Body Repair Manual Welding & Sectioning Guideline Revisions

(Supersedes original publication, issued **April 2014**, to clarify procedures and add the latest information)

In response to requests from the collision industry as the amount and tensile strength of steels used in our vehicles increase, Acura has made some significant changes to the approved welding methods and parts sectioning guidelines published in the body repair manuals. These changes will be integrated as each model's body repair manual is revised. The changes described here apply to all models and supersede previously published information.

Rear Inner Panel Service Part Example

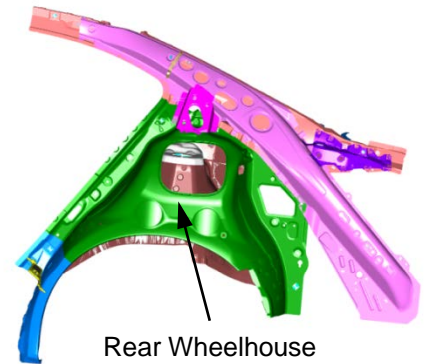
- Replacement of body service parts as supplied at factory seams is the preferred repair method, except when it may cause unnecessary or excessive intrusion into the body structure.
- In these cases, the service part may be disassembled at factory seams as required to replace only the damaged portion.
- For example, if only the vehicle's rear wheelhouse is damaged, that part may be removed from the rear inner panel service part assembly at the factory seams and installed on the vehicle.
- Note that there is **not** a BRM replacement procedure for rear inner panels because they are rarely installed as a complete unit.
- All basic welding & sectioning guidelines specified in the service information **must** be observed during partial panel replacement.

Sectioning Area Examples

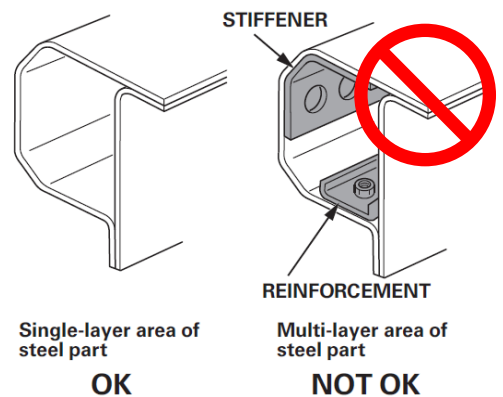
- Outer body and floor panels may be sectioned as necessary. Specific sectioning procedures are not provided in the body repair manual.
- Depending on the type of vehicle damage, steel parts with a tensile strength of 780 MPa or less may be sectioned **if all three of the following conditions are met:**

1. Sectioning must be done in a single-layer area of the part.
 2. Multi-layer internal steel reinforcements and stiffeners must not be cut.
 3. Do not section in load bearing areas, such as engine, transmission, or suspension mounting points.
